Attachment E

Location and Type of NESC Violation

Re: Oncor Safety Violations

1

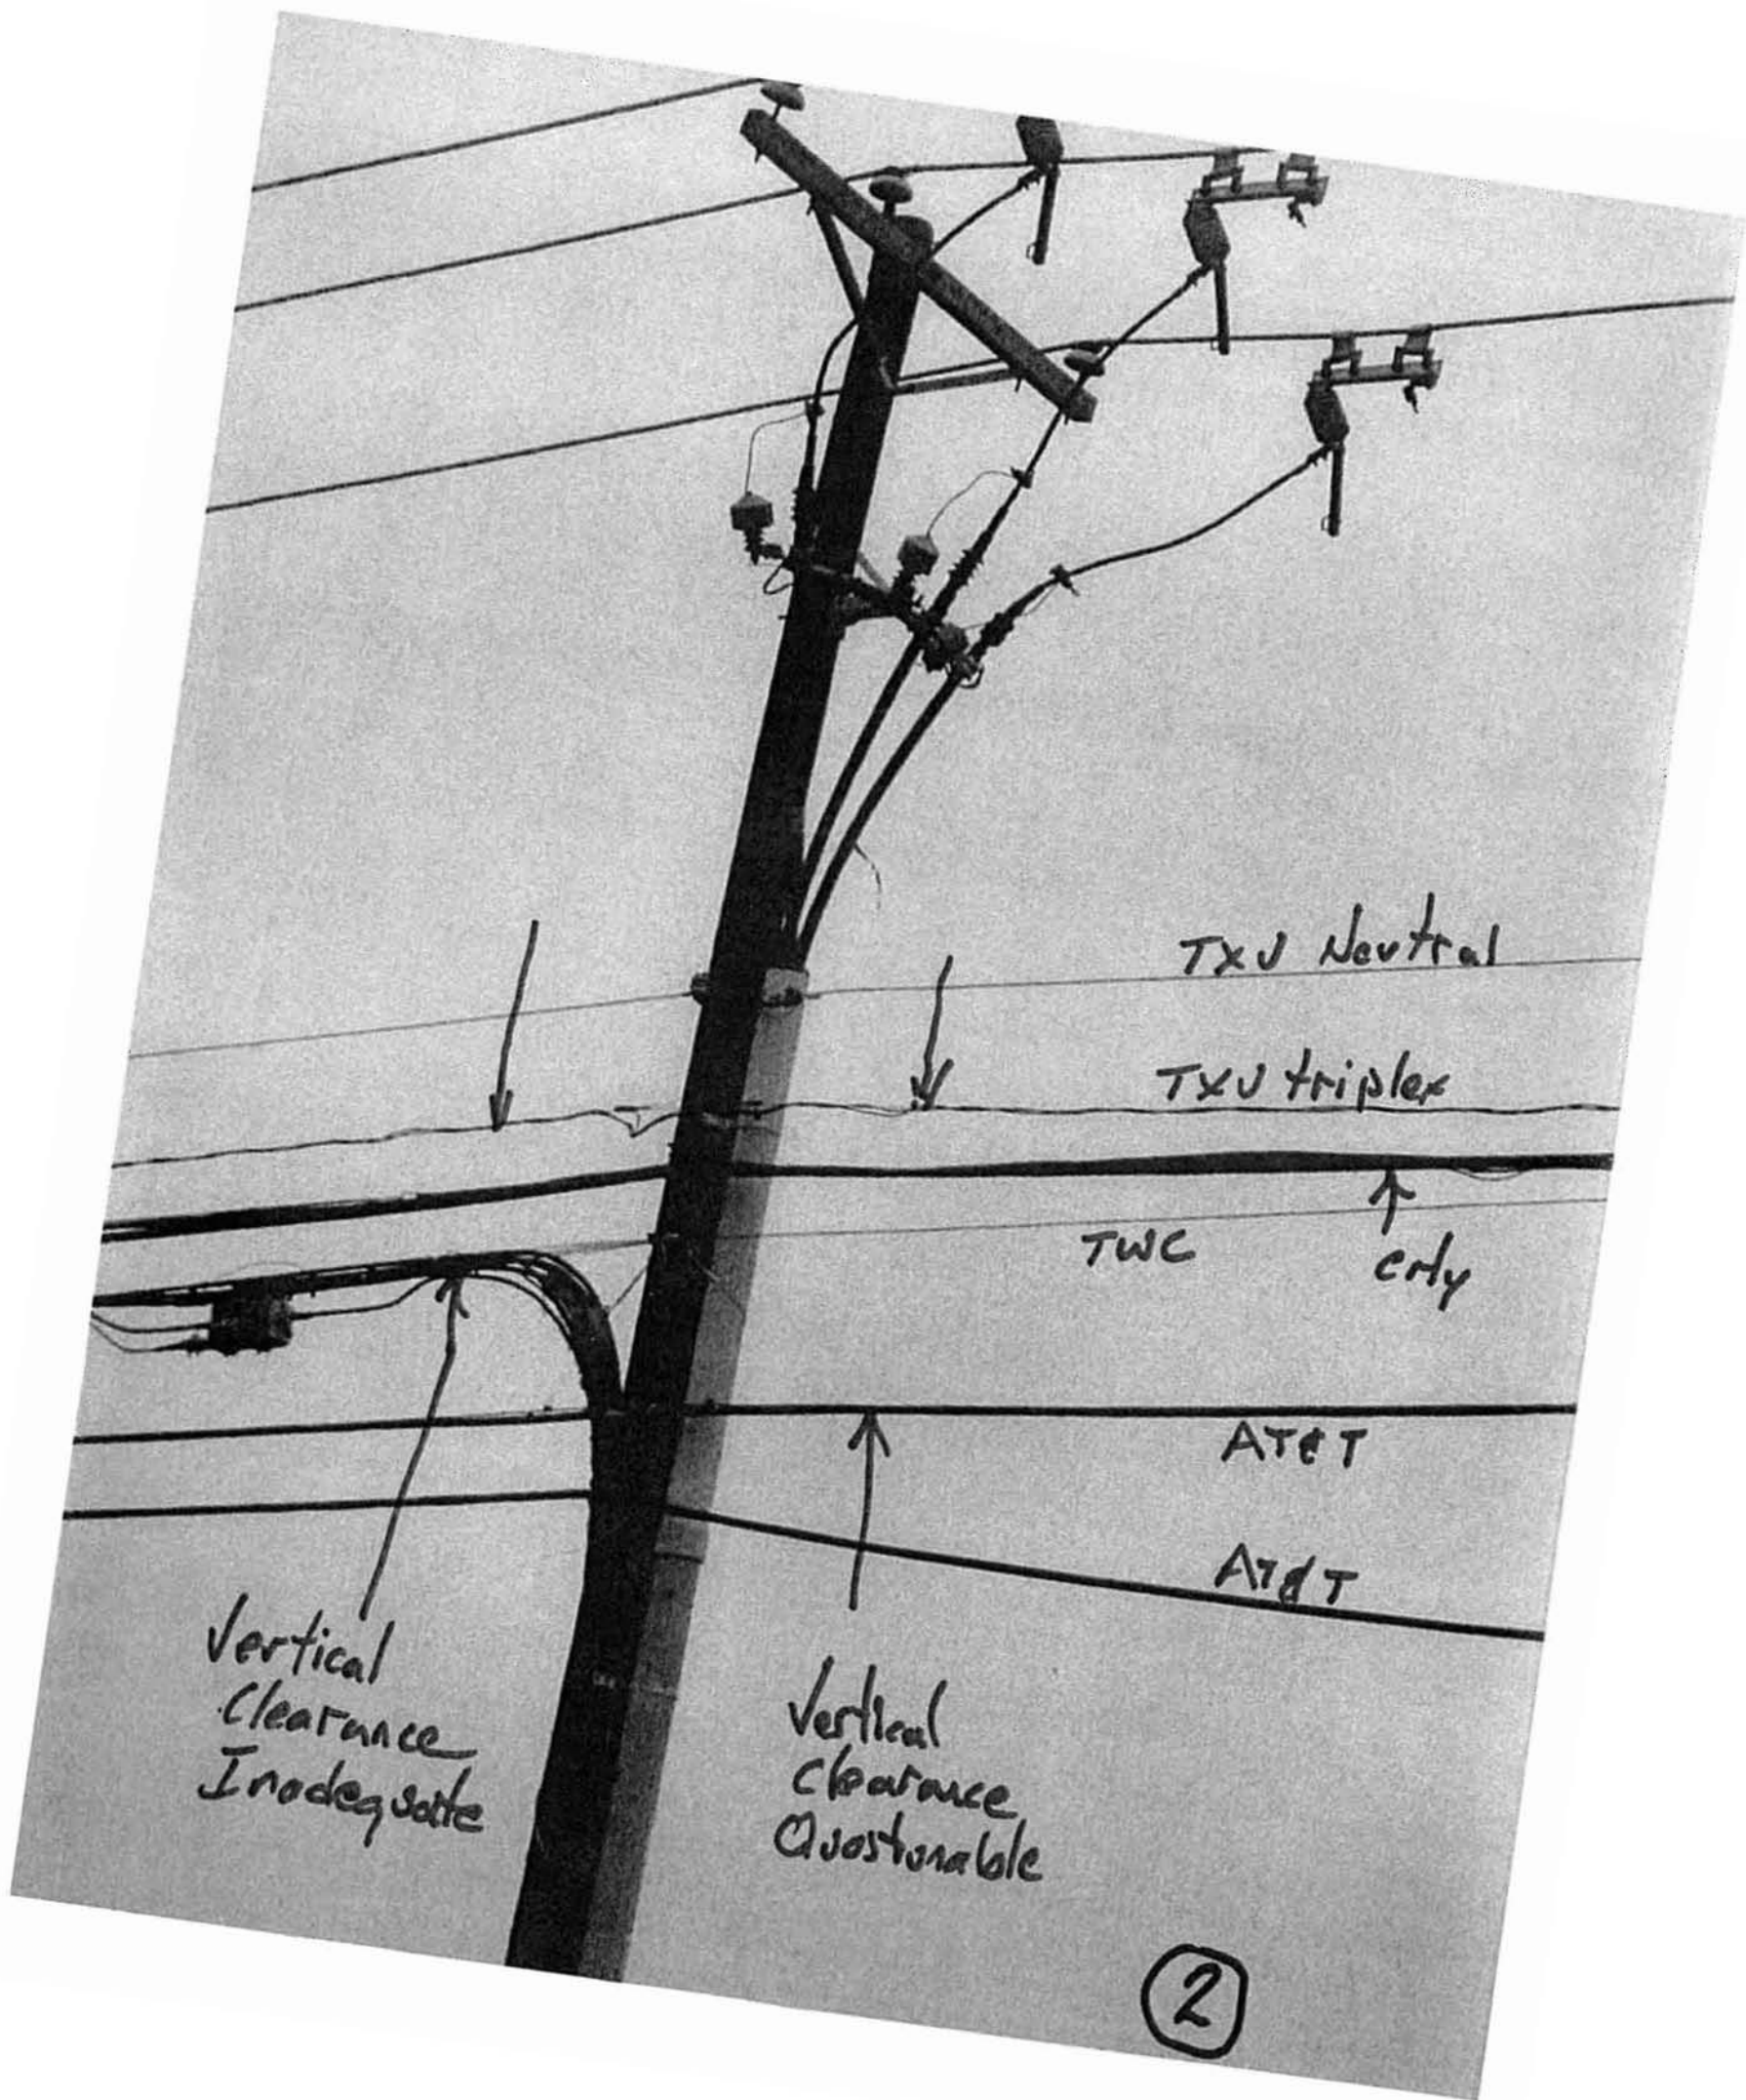
TXU riser cables
not protected
above conduit

3

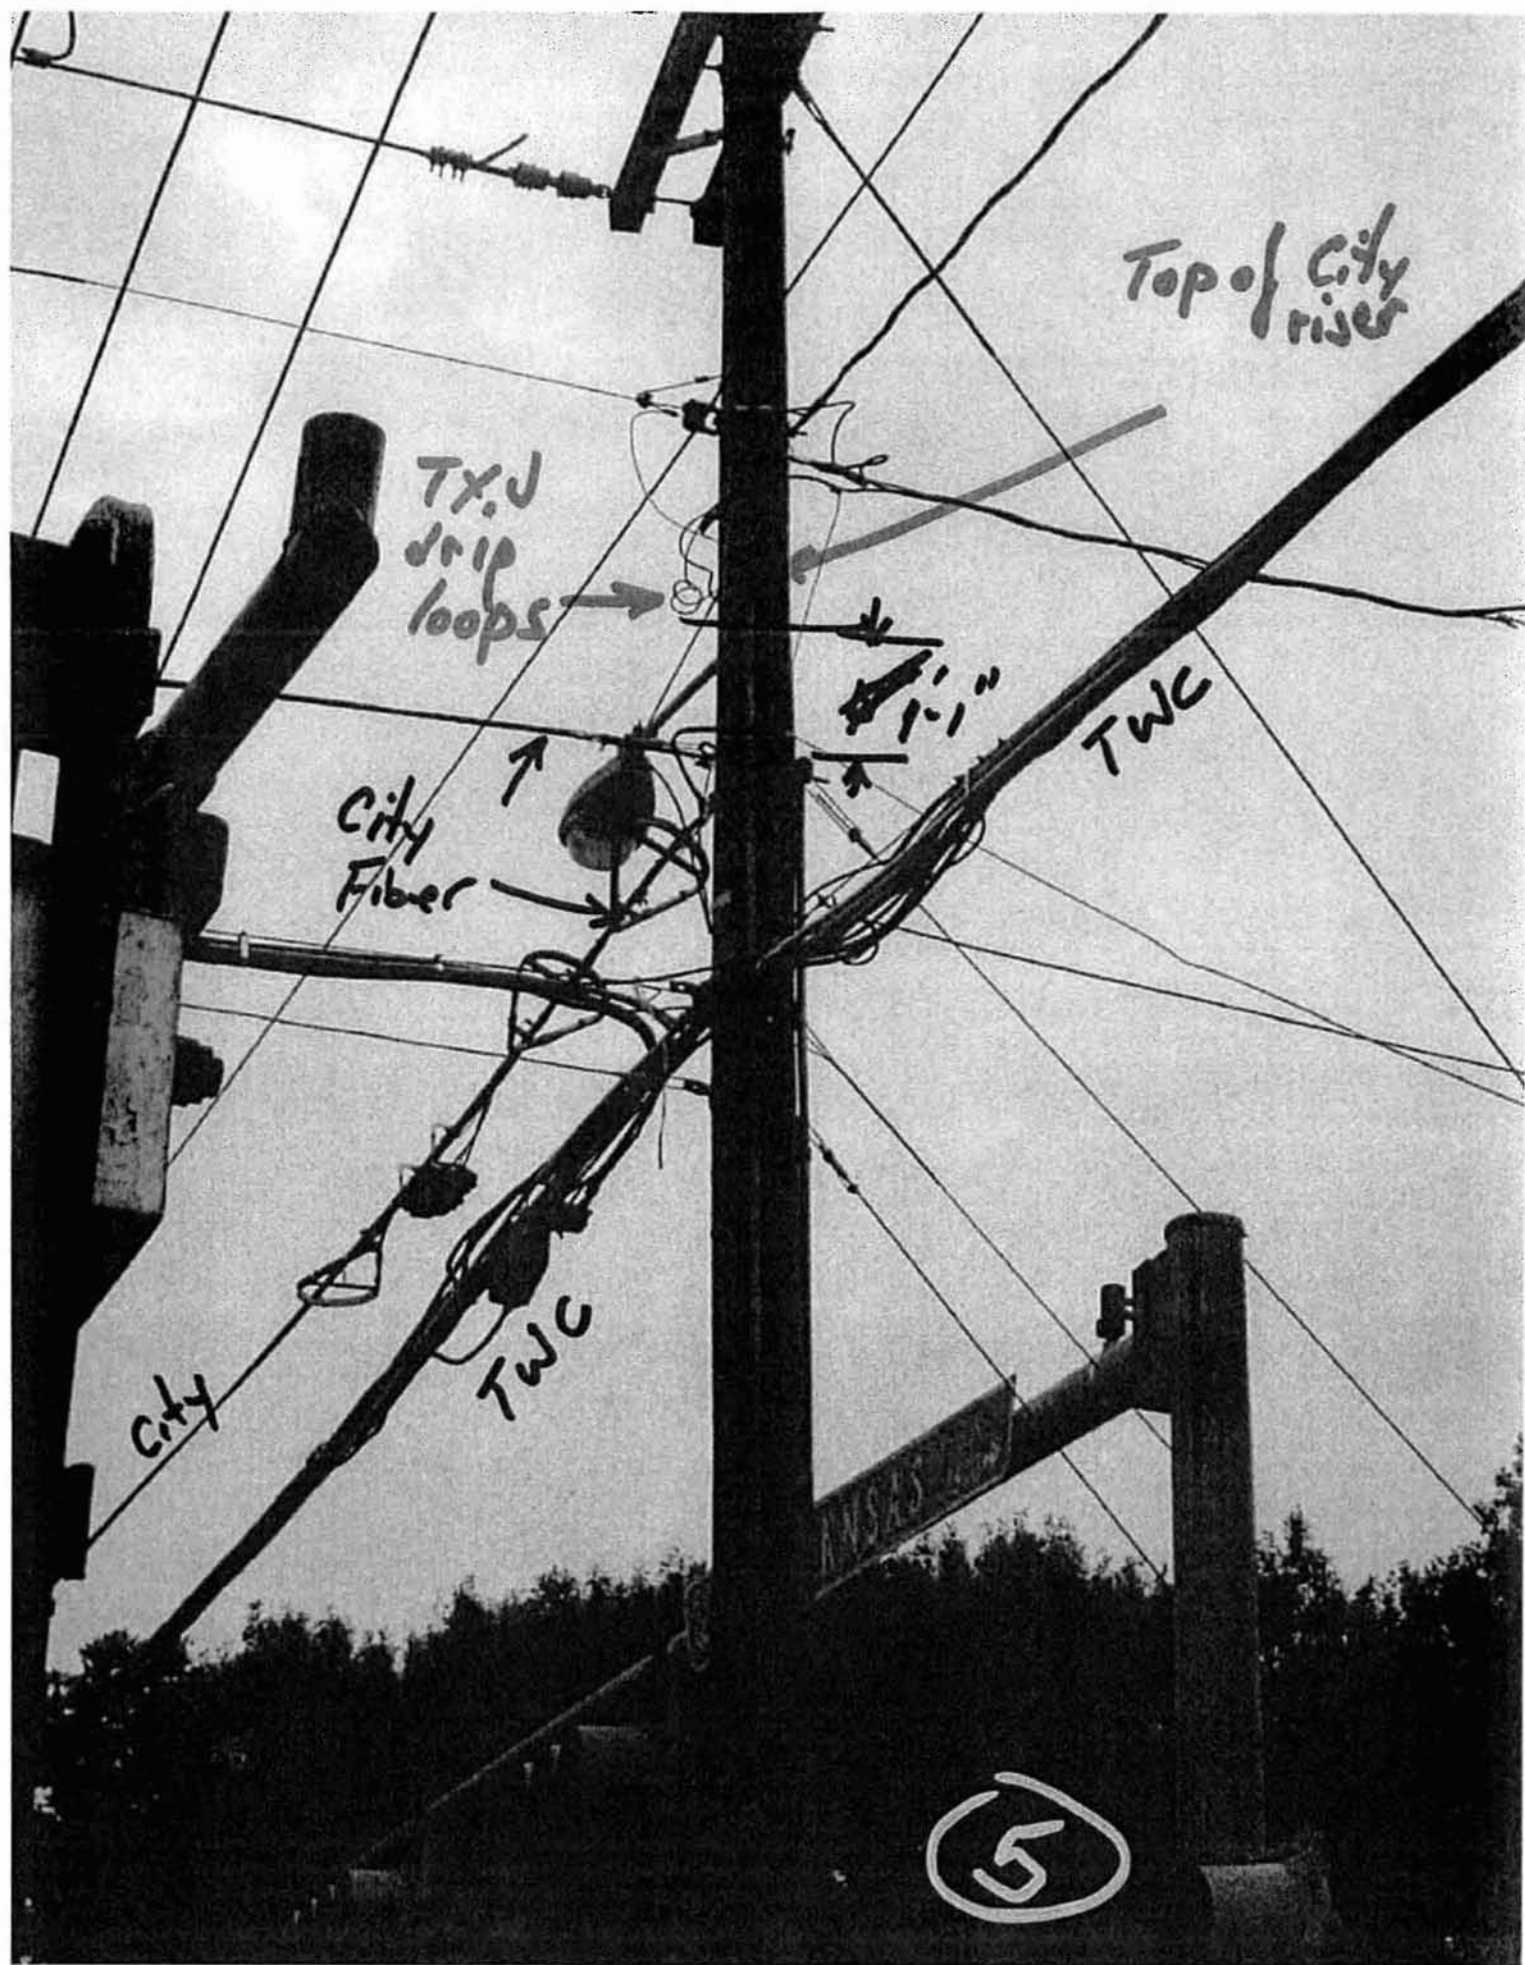
TXJ riser cable
- Unprotected -
to below TWC

Unprotected
TXJ riser
cable
below
TWC

Remediated

Riser Conduits
Extended

(9)

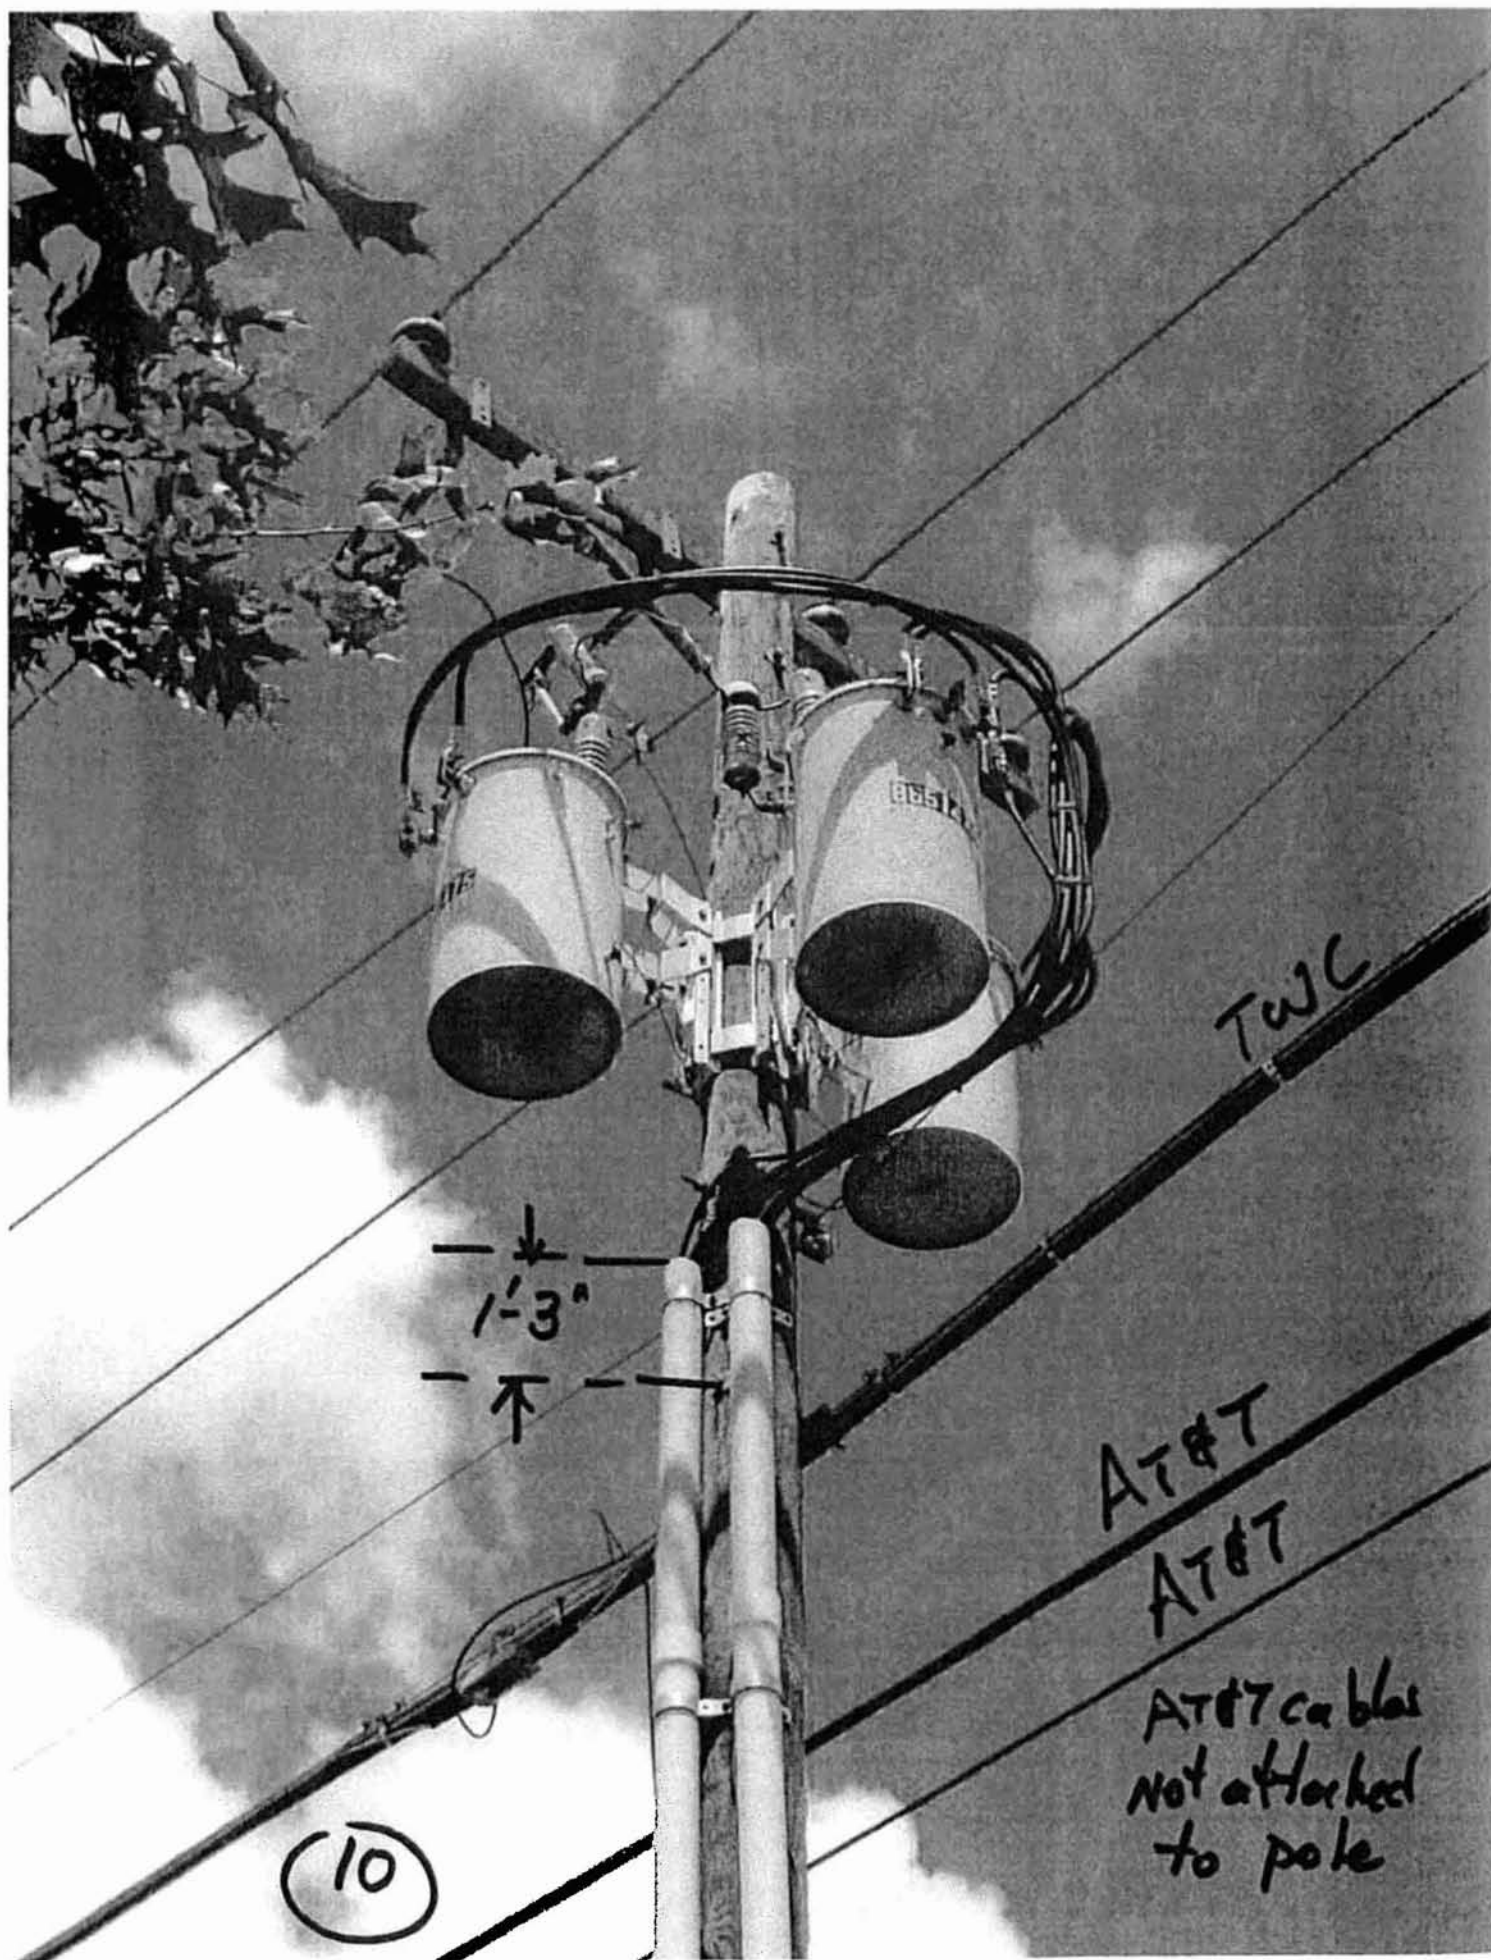
AT&T cables
not attached
to pole
